# TECHNICAL BULLETIN

## [Issue No.] T10-0017

[Title] Notice of improved operability of the GOT-A900 Series when inserting and removing the PC card

[Relevant Models] A975GOT, A970GOT, A960GOT

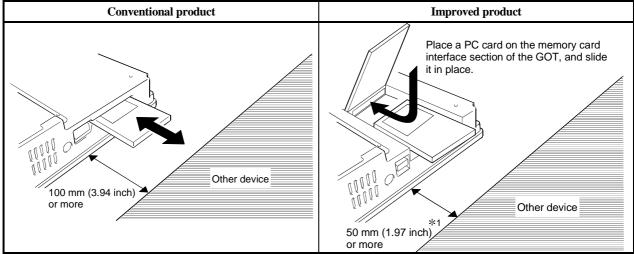
The rear case of the GOT-A900 Series has been improved so that less space is necessary for inserting and removing the PC card.

You can now open the cover of the memory card interface on the GOT with improved structure, as shown below (hereinafter referred to as the improved product).

This new design reduces the space for inserting and removing the PC card by 50 mm (1.97 inch) as compared with conventional products.

- \*1 If a communication module is mounted on the GOT, you cannot open the cover of the memory card interface. It is thus necessary to place the GOT at least 100 mm (3.94 inch) away from other devices, in the same manner for conventional products.
- \*2 The PC card may pop out when it is removed, depending on the type of the PC card used. Be sure to support the card with your hand when removing it.
